DOCKET NBR: 502331 DUANE ARNOLD  
RECIPIENT: STELLO, V.  
ORIGINATOR: PUGH, R.  
COMPANY: RICHARD PUGH, P.E.  
SUBJECT:

Submits questions re fluid mechanics at subj facil as a result of 781114 pub meeting in Cedar Rapids, IA. W/encl diagrams from Cedar Rapids Gazette.

Re: Duane Arnold Energy Center  
Palo, Iowa

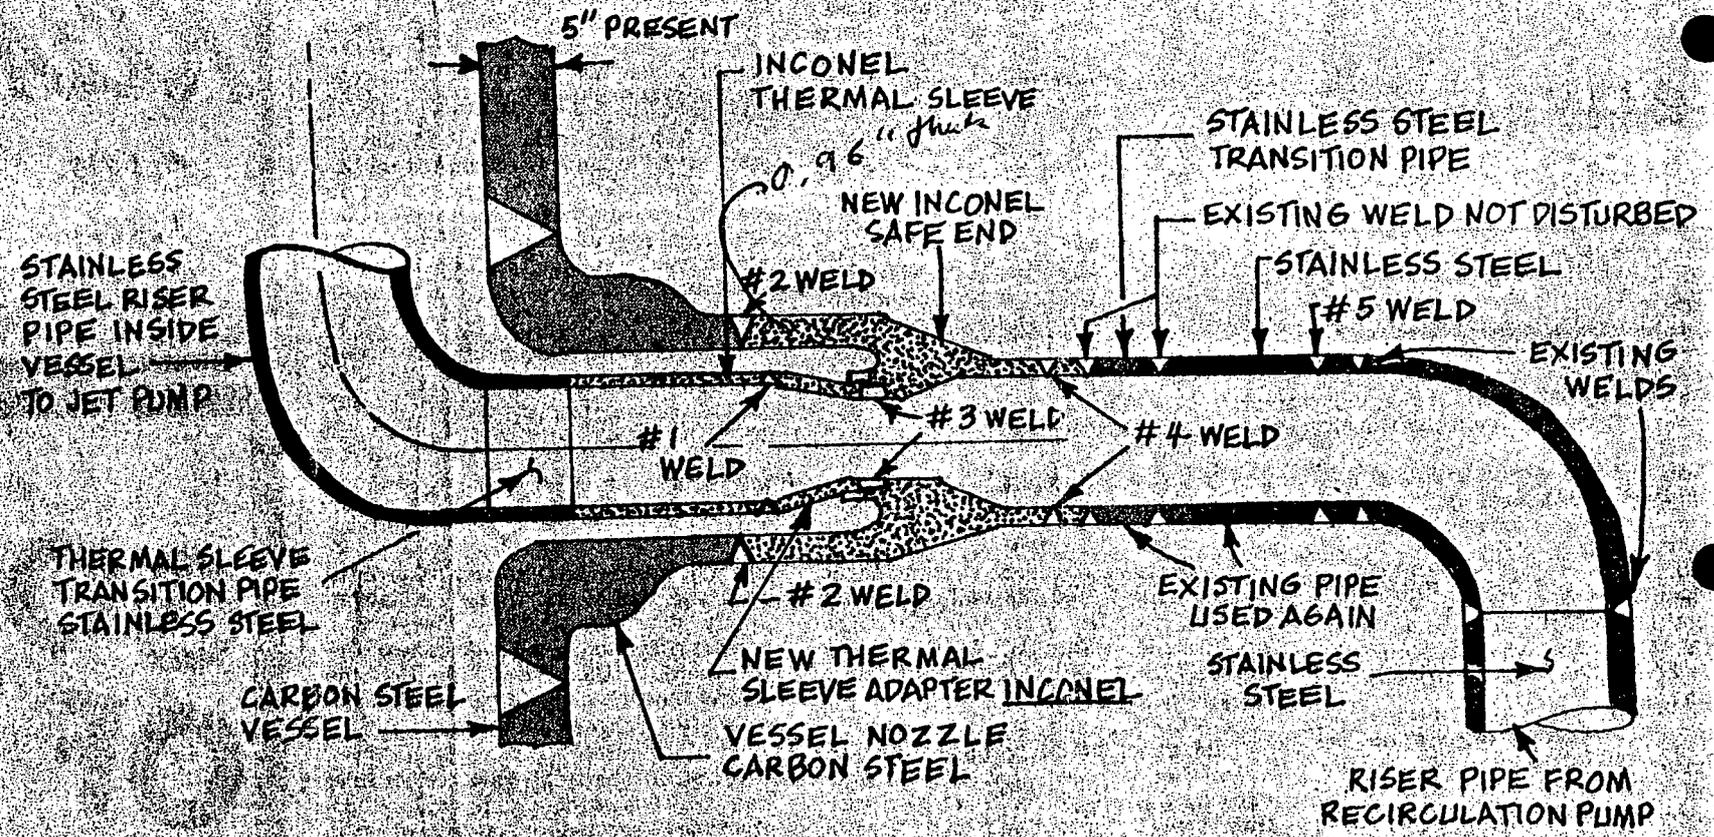
As so often happens, I think of a question too late to ask at the right time, and would appreciate your response to these questions regarding the fluid mechanics aspect. Enclosed is a copy of the new design, as it appeared in the Cedar Rapids Gazette, November 12, 1978. I assume that the constricted actually used must be smoother, and possibly less severe than that shown on the picture.

1. What is the diameter of the pipe at the # 3 weld?
2. Is the coolant water?
3. What are the temperature and pressure of the coolant in the pipe, or range of temp. and press. during normal operation?

4. What is the direction of flow of the coolant, and velocity of flow?
5. What is the anticipated pressure at the narrow cross-section (Bernoulli effect) in p.s.i. absolute?

6. What consideration has been given to possibility of cavitation of the liquid? Will the transition from full pipe diameter to constricted, and back to full diameter be ground smooth, with good radii of curvature, and will weld # 3 be ground smooth to prevent local spots where cavitation could occur? Has a prototype been tested for possible cavitation?

7. Regarding the annulus--in the scale model tests referred to yesterday to determine the flushing action, was the model operated at the same Reynolds number as one would expect for the full scale part? Was the ratio of roughness in the model to roughness in the full scale ~~xx~~ the same as the ratio of size of model to size of full scale? Was the flow in the annulus in laminar or turbulent condition?
